CNL-20-057

Sequoyah Nuclear Plant, Units 1 and 2  
Renewed Facility License Nos. DPR-77 and DPR-79  
NRC Docket Nos. 50-327 and 50-328

Subject: **Application to Revise Sequoyah Nuclear Plant Units 1 and 2 Updated Final Safety Analysis Report Regarding Changes to Hydrologic Analysis - Partial Response to Additional Request for Additional Information (TS-19-02) (EPID L-2020-LLA-0004)**

### Response to NRC Additional Request for Additional Information, Question 1

Figure 1

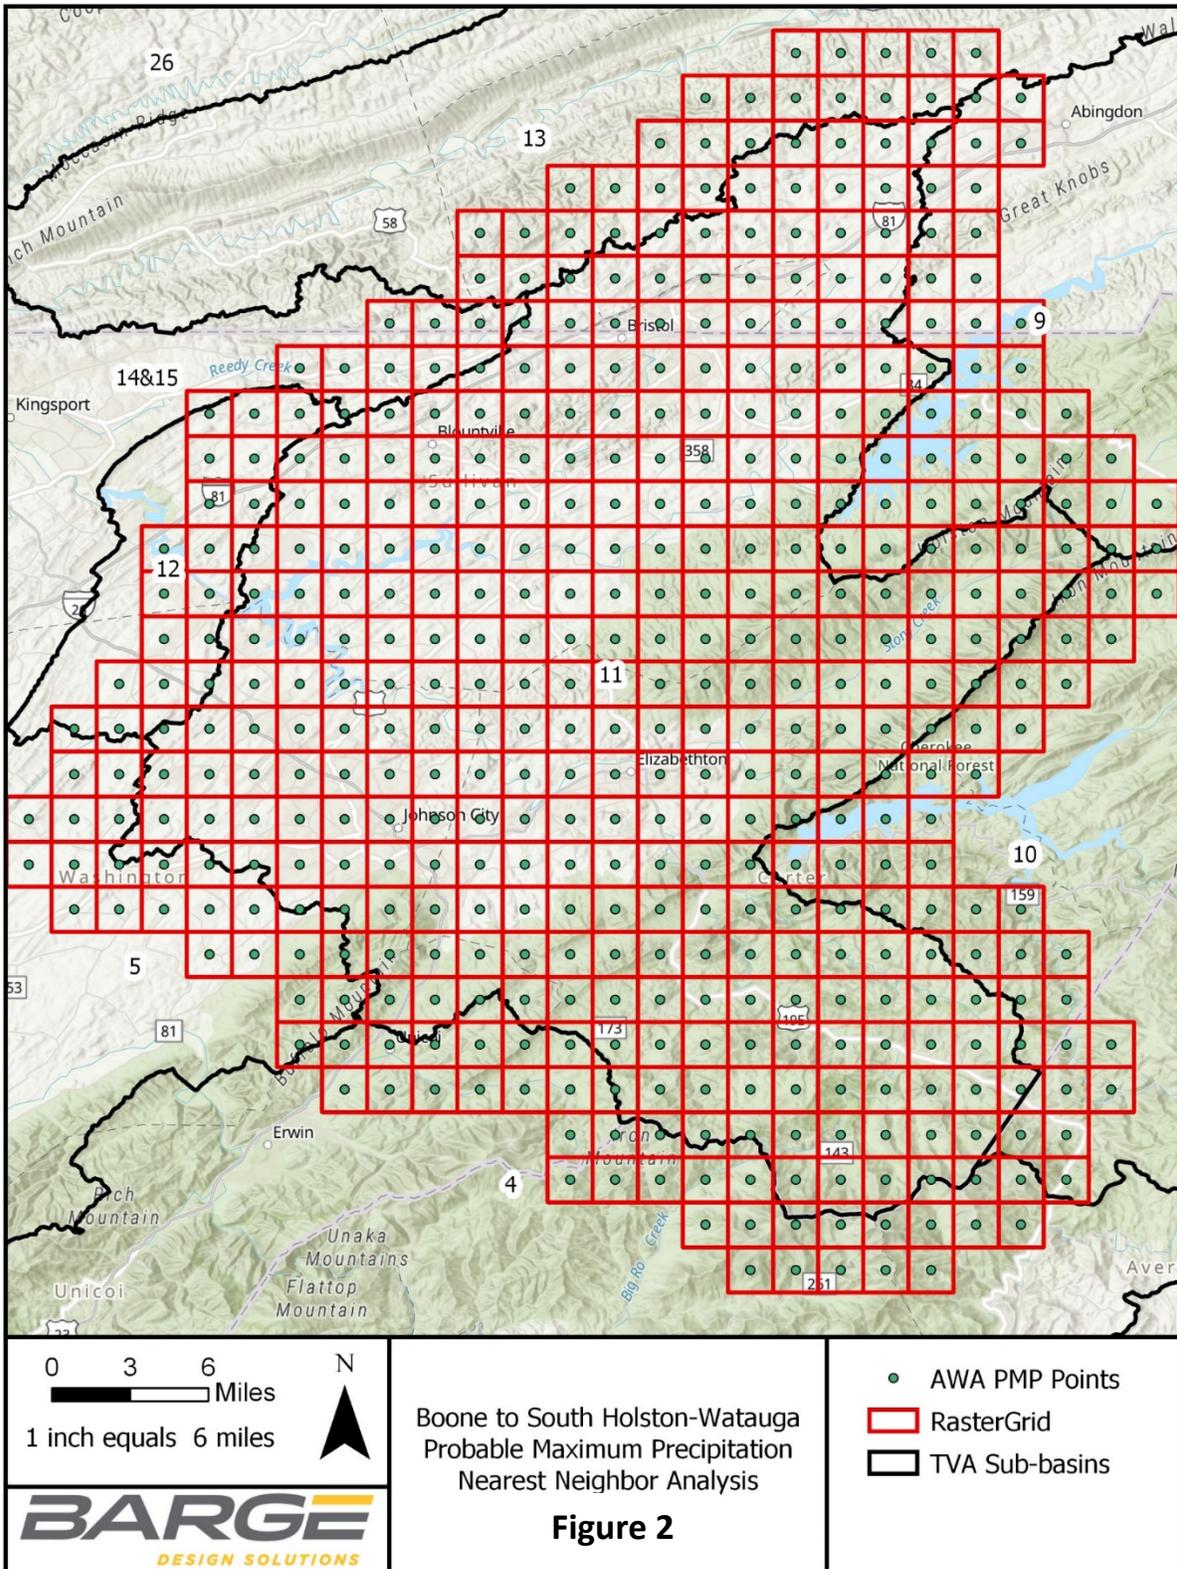
- 1. TVA stated that the ArcGIS software uses gridded shapefile data to create a Triangular Irregular Network (TIN) surface that is used via a polygon volume tool to compute the sub-basin average Probable Maximum Precipitation (PMP) depths. In contrast, the QGIS alternate methodology utilizes the nearest neighbor geoprocessing tool to generate a raster surface that then uses a grid statistics tool to generate the nearest neighbor geoprocessing tool. It is unclear what the technical difference is between methodologies used to create a TIN surface and a raster surface and between the polygon volume tool and nearest neighbor geoprocessing tool used to create the sub-basin average PMP depths. Therefore, the NRC staff requests TVA to clarify how these two methodologies are technically different such that the use of these alternate calculation methodologies can be credited to prevent the same erroneous outputs in both GIS tools.*

The Applied Weather Associates (AWA) PMP Evaluation Tool outputs PMP depths along a uniform grid with a resolution of 0.025 by 0.025 decimal degrees or 90 arc-seconds. Figure 1 below graphically displays the Delaunay triangulation utilized between points to develop a surface of PMP depths across the project area. The centroid of each grid cell is connected by triangles where the surface, in this case PMP depths, is represented by a plane. The polygon volume tool utilized in ArcGIS then calculates the volume between the surface of PMP depths across the project area and a constant height of zero thereby providing the PMP volume. Conversely, the QGIS processing takes the same PMP depth grid and uses the nearest

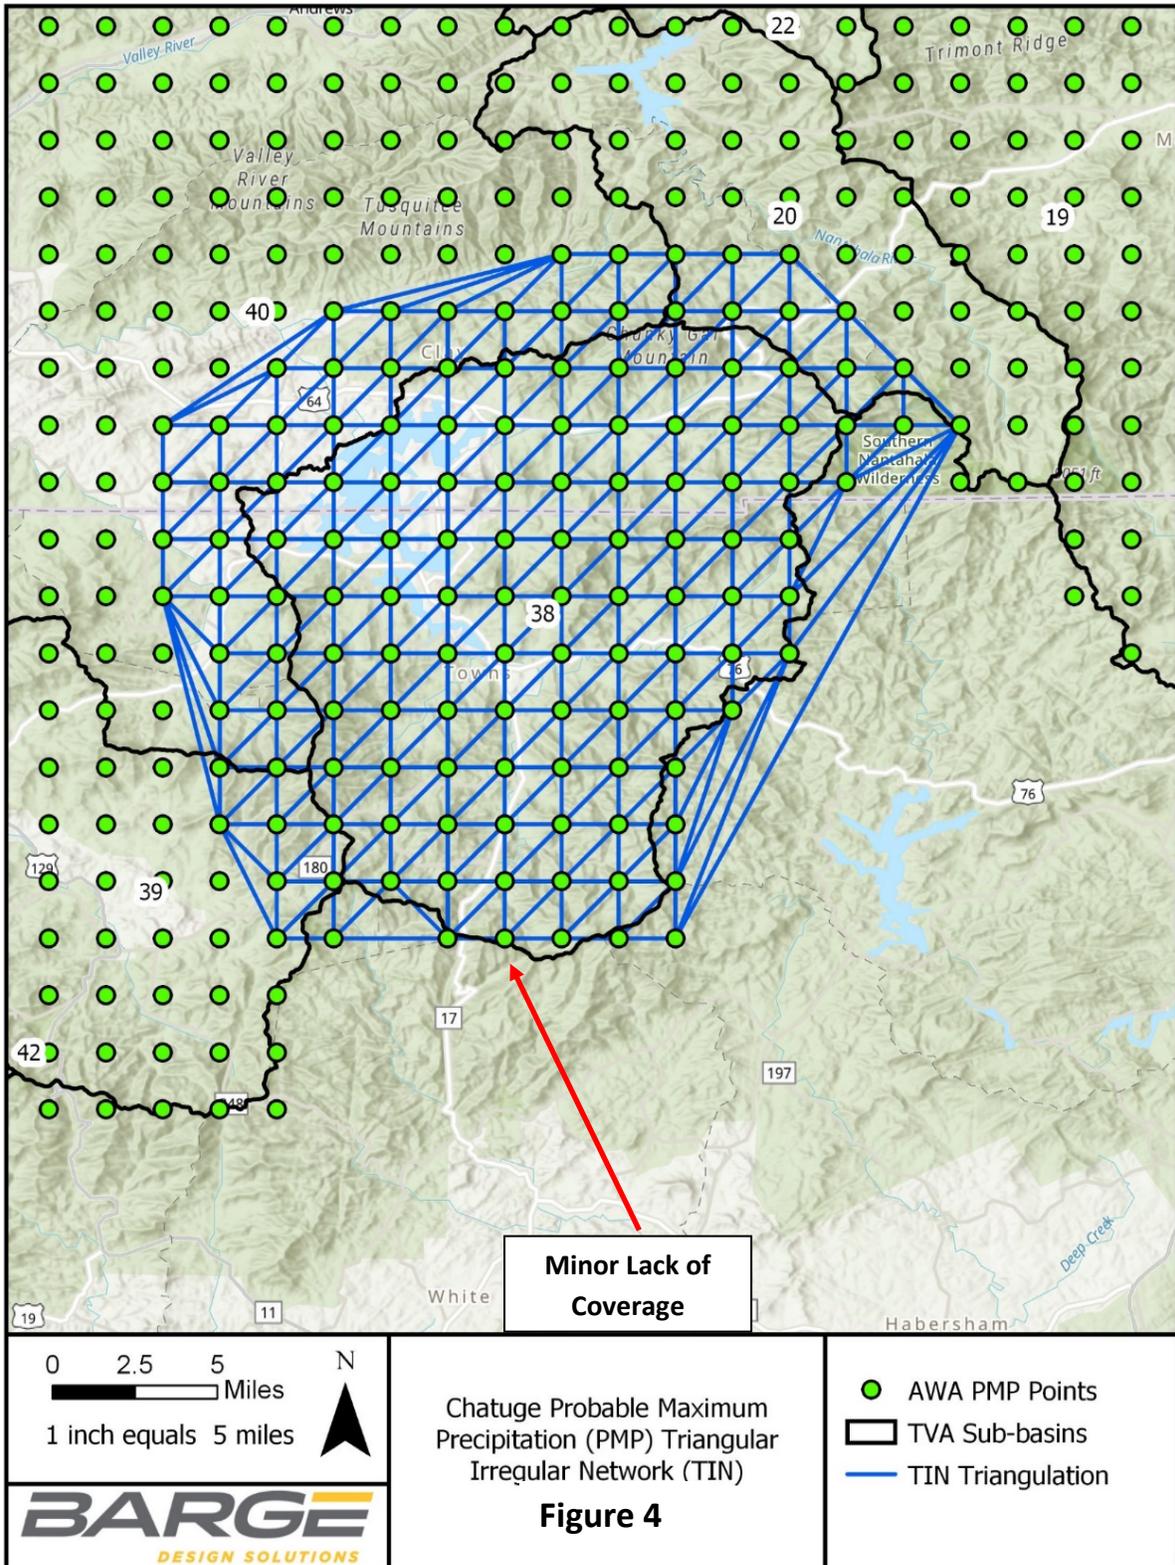
2. *In Enclosure 3, "Gridded PMP Development Calculation" of the RAI response, Appendix A "GIS PMP Event Depth Computations," Section 6.5, states "Review of computed PMP depths across the ArcGIS and QGIS platforms identified a project PMP depth above Chatuge as an outlier. Analysis indicated areas around the sub-basin boundary with zero depth as the PMP points from the [Applied Weather Associates (AWA)] tool did not provide adequate coverage during TIN creation for the single sub-basin. PMP depths utilized for Chatuge are based on QGIS analysis to eliminate results without the complete PMP coverage." Since QGIS is used to verify the results of ArcGIS and their results are dissimilar for Chatuge, it is not clear what the basis is for using the output of QGIS instead of ArcGIS for this area. In addition, since the TVA determined that ArcGIS did not provide adequate coverage for Chatuge, it is not clear how the output of QGIS is determined to be correct for this area. Therefore, the NRC staff requests TVA to justify the use of the QGIS output for the Chatuge sub-basin.*

The determination of the Chatuge project area PMP depths when utilizing the Delaunay Triangulation feature in ArcGIS covered nearly 100% of the basin area, as graphically shown in Figure 4 (see the slight lack of coverage shown at the southern tip of the basin). The portion of the Chatuge watershed without the PMP TIN coverage is approximately 0.88 square miles equating to less than 0.5% of the total Chatuge watershed area.
